CHRISTOPHER B. BURKE ENGINEERING, LTD.

July 3, 2014

Subject: City of Elmhurst Comprehensive Flood Plan
Park District Properties Peer Review
(CBBEL Project No. 10-0506)

Figure 5. Plan View of EE Site in the CFP NCalCritical Existing Model

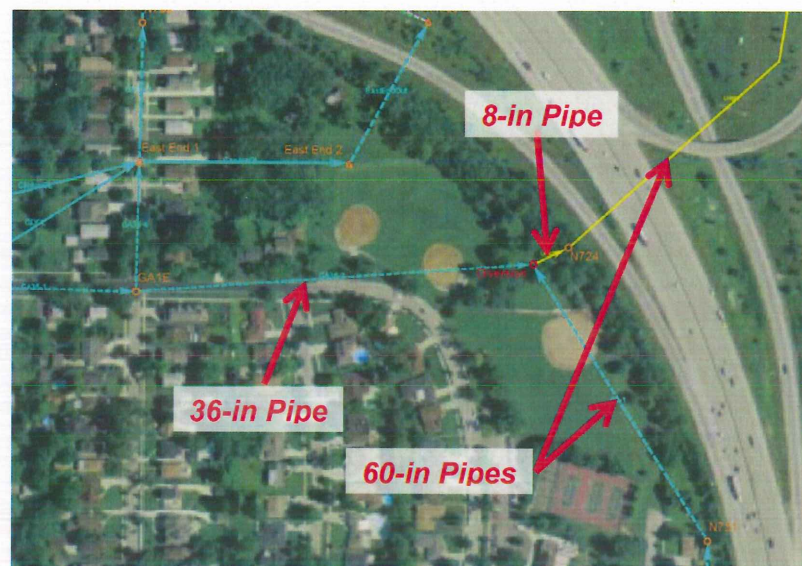
V3 Observation #5: East End Park. The NCalCritical existing condition model describes a short 8-inch diameter pipe (Link673) downstream of the junction of a 36-inch sewer and a 60-inch sewer (60-1). The junction is labeled Diversion and the short 8-inch diameter pipe joins to a 60-inch pipe further downstream (Link665) at node N724 (see Figure 5 below).

CBBEL Response #5: The as-built plans for the Lower Elmhurst Reservoir show a structure in East End Park with a sluice gate that diverts stormwater away from the North Avenue storm sewer system into the Lower Elmhurst Reservoir. Low flows to the diversion structure are bypassed around the sluice gate to the North Avenue storm sewer system through an 8-inch diameter pipe. High flows are designed to backup into the Lower Elmhurst Reservoir. The sluice gate has been field-verified by both CBBEL and City staff and the XP-SWMM hydrologic and hydraulic modeling that was prepared for this study area reflects this configuration.

Because it would send additional water downstream to another known flood problem area (North Avenue), removing the sluice gate in East End Park is not considered a viable solution to the flooding along Geneva Avenue.
